Permit Type Building/Residential/Addition/SFD Permit Number B25002804 Opened Date 07/17/2025

SFD/ CONSTRUCT 5 X 21 (1) STORY ADDITION ON FRONT FOR EXPANSION OF LIVING ROOM, 12 X 21 (1) STORY ADDITION ON REAR FOR DINING ROOM, RAISE ROOF, NEW SCISSOR TRUSSES TO OPEN SPACE, RENOVATIONS TO KITCHEN/ LIVING ROOMS, CONSTRUCT 6 X 21 IRREGULAR SHAPED DECK, 6 X 21 PORCH ON FRONT/, 1 STORY, Post & Pier, 1R, 0FB, 0HB, 0FP, OTHER STRUCTURE = None, 0BR, PORCH/DECK = Open Porch and Deck, ENERGY METHOD = Prescriptive Method,

Street # 1045 Street Name LONG CORNER Street Type RD
 Unit Type -Select- Unit # X Coordinate -77.14342 Y Coordinate 39.33981
 City MOUNT AIRY State MD Zip Code 21771 Primary Yes

From: Oswald Jr, Woodin
Sent: Wednesday, September 10, 2025 11:56 AM
To: d.mast@mastconstructionllc.com
Subject: RE: B25002804_1045 Long Corner Road
Attachments: County Waiver Form interactive_Perc Cert Plan Requirements.pdf; office as built_250910_113024.pdf; SEPTIC CONTRACTORS 2.4.2020.pdf

Site Visit – 9/9/25
1045 Long Corner Road
Mt. Airy, MD 21771

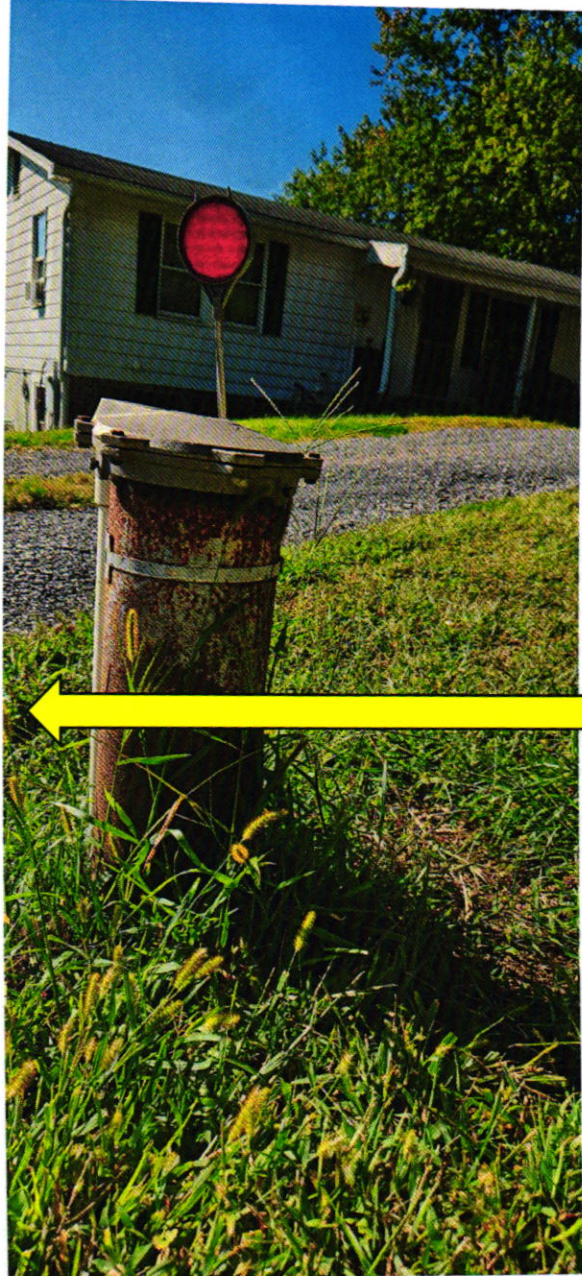
COMMENTS: Well is located 3' from d/w. PVC conduit is disconnected from well cap.

The well is located 3 feet off driveway.

During my site visit, I observed the manhole cover was damaged, so you will need to contact a licensed septic contractor to repair it. The septic contractor must obtain a minor septic repair permit from this office to replace the manhole cover before doing the work. In addition, the well had a broken/disconnected pvc conduit, so that needs to be repaired. Lastly, the well did not meet the 10 foot setback to the driveway, so you will need to install bollards or large boulders around the well to protect it from traffic on the driveway.

Site Visit – 9/9/25
1045 Long Corner Road
Mt. Airy, MD 21771

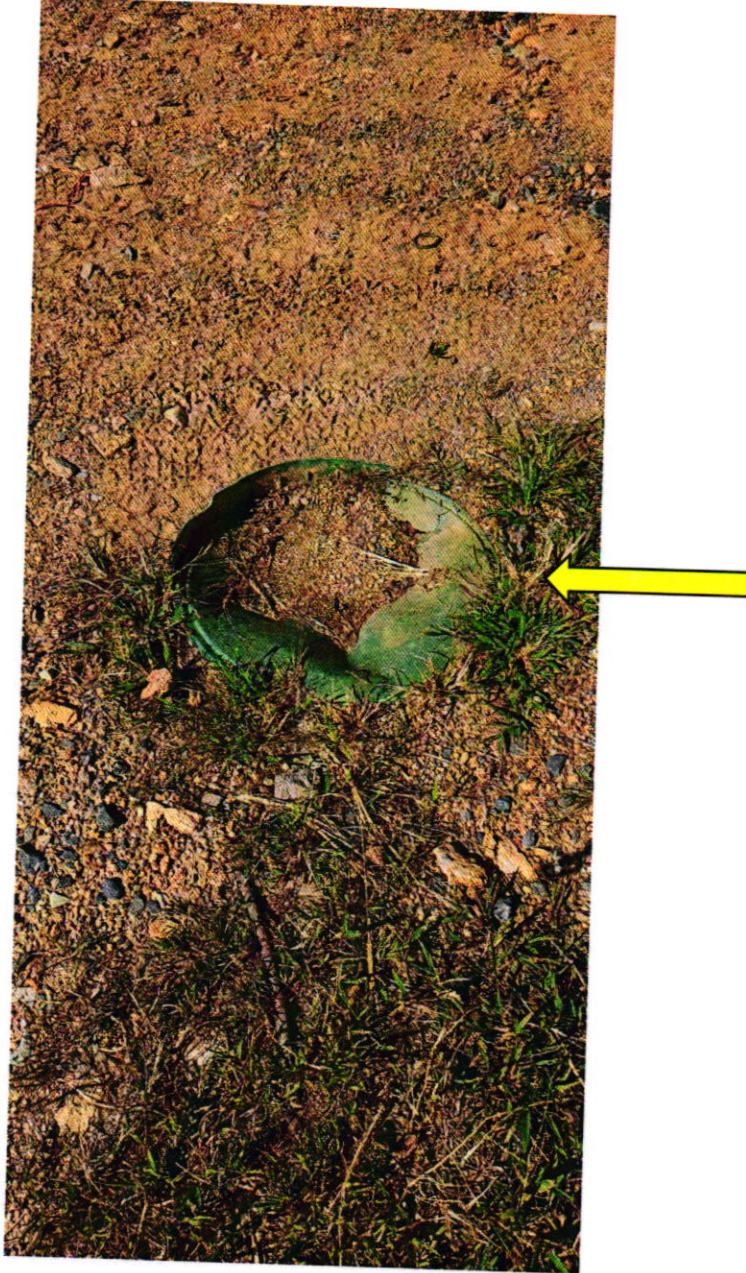
Septic tank manhole cover is damaged.

Site Visit – 9/9/25
1045 Long Corner Road
Mt. Airy, MD 21771

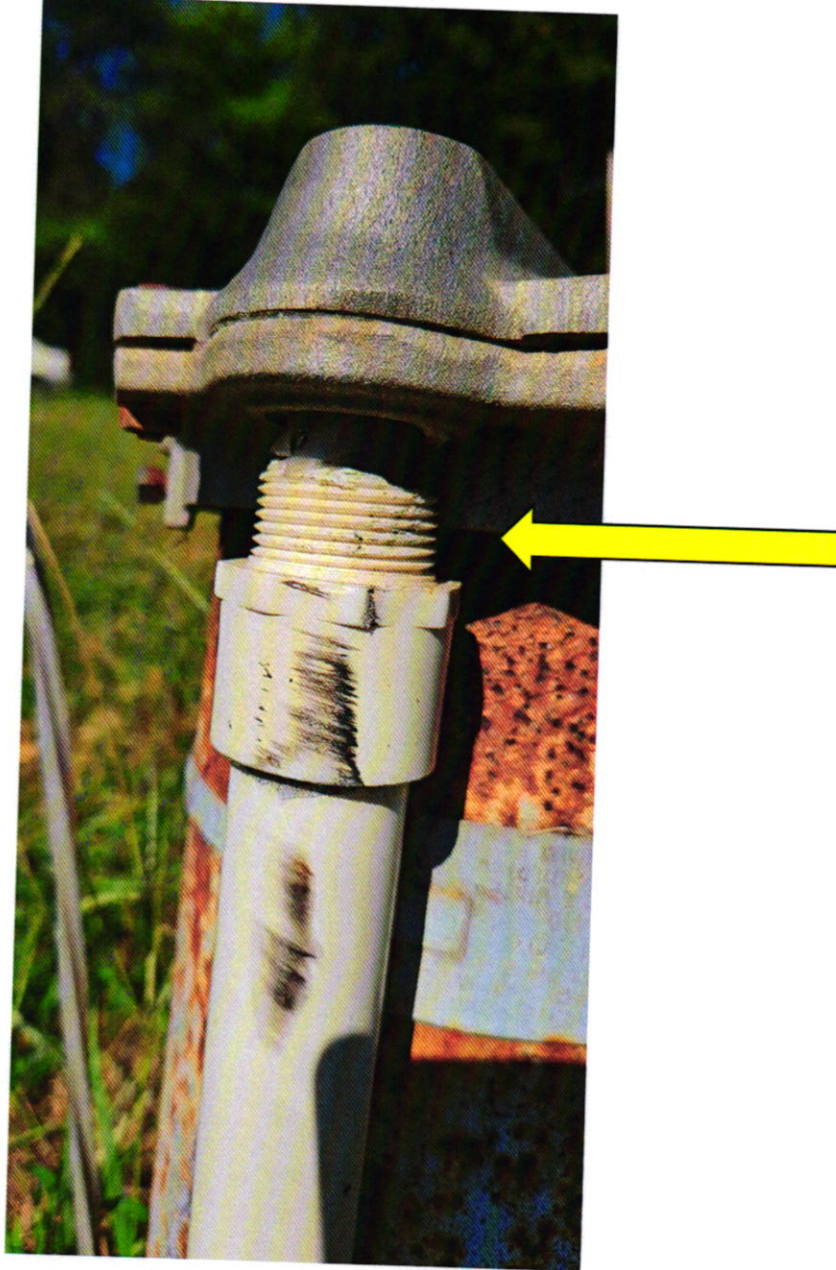
PVC conduit is disconnected and appears damaged.
